PREVOST

WARRANTY BULLETIN

WB13-62B

| SUBJECT : | TORQUE INSPECTION ON FRONT AXLE SUPPORT BOLT | | |

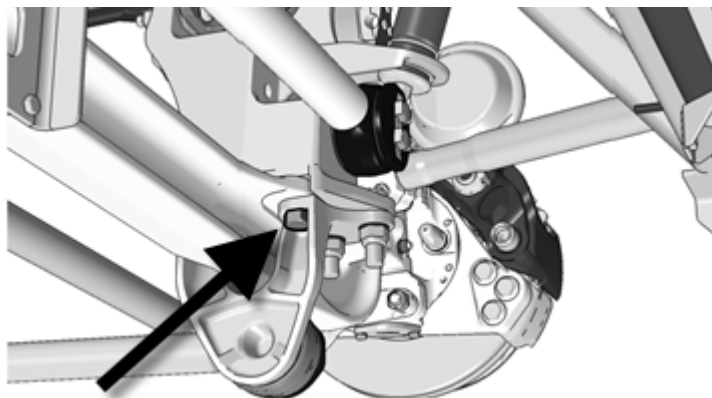
On the vehicles affected by this bulletin, torque must be verified on one of the axle support mounting bolts. An interference of a production tool with the casting on the nut side of the fastener may have resulted in lower effective torque.

1. On the front axle, left side (driver's side). Locate this bolt (arrow).

2. Verify the torque on this bolt.

Value should be

255 +/- 25 lbf-ft. (**230 - 280** lbf-ft).

If value is within range, clean and apply torque seal mark.

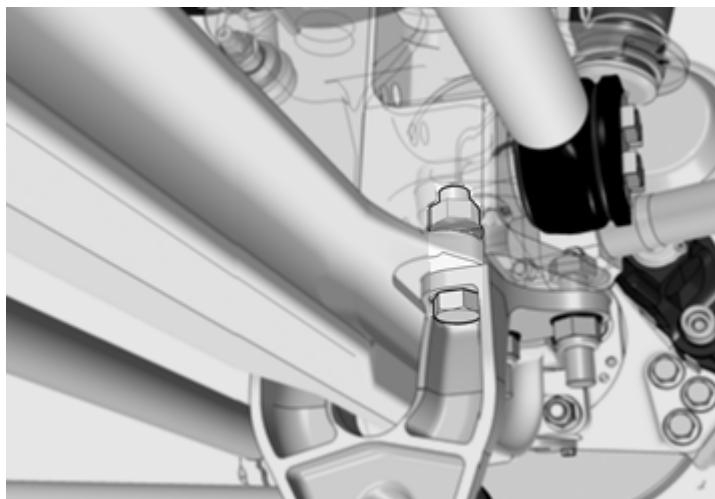
3. If torque is outside the required range, unscrew half a turn and tighten to 255 lbf-ft.

Clean and apply torque seal mark.
